Access Compliance Report

Public Rights-of-Way

Intersection ID: 10036258	Main Street: ROMANY_RD	Cross Street: N/A	Location: SE
ADA ID: 3C31EC906FE2	Ramp Type: PerpDiag	Initial Pass/Fail: Fail	Overall Compliance: No
		Severity Score: 10

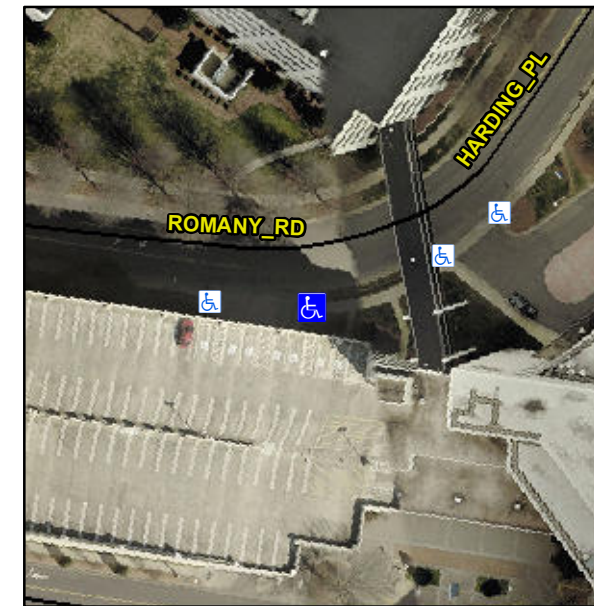
Not Found, R304.5.1, R304.5.3

Compliance	Description	Data	Compliance	Description	Data
N/A	Ramp Length (in)	61.0	Yes	Ramp Slope (%)	5.2
No	Ramp Width (in)	36.5	No	Ramp XSlope (%)	4.7
N/A	Flare Type LT	N/A	N/A	Flare Type RT	N/A
N/A	Flare Slope LT (%)	N/A	N/A	Flare Slope RT (%)	N/A
N/A	Flare Traversable LT?	N/A	N/A	Flare Traversable RT?	N/A
N/A	Landing Length (in)	N/A	N/A	DWS Provided?	N/A
N/A	Landing Width (in)	N/A	N/A	DWS Contrast?	N/A
N/A	Landing Slope (%)	N/A	N/A	DWS Length (in)	N/A
N/A	Landing X Slope (%)	N/A	N/A	DWS Full Width?	N/A
N/A	Landing Curb? (Y/N)	N/A	N/A	DWS Offset (in)	N/A
N/A	Shared Landing?	N/A			
N/A	Gutter Ponding?	N/A	N/A	Gutter Slope (%)	N/A
N/A	Gutter Lip Ht (in)	N/A	N/A	Gutter X Slope (%)	N/A
N/A	Painted X Walk1?	No	N/A	Painted X Walk2?	No
	X Walk 1 Direction	To NE		X Walk 2 Direction	To NW
N/A	X Walk 1 Width (in)	N/A	N/A	X Walk 2 Width (in)	N/A
	X Walk 1 Slope (%)	3.7		X Walk 2 Slope (%)	0.8
	X Walk 1 X Slope (%)	0.7		X Walk 2 X Slope (%)	5.4

Remove & Replace Curb Ramp With Two New Directional Ramps or Equivalent.
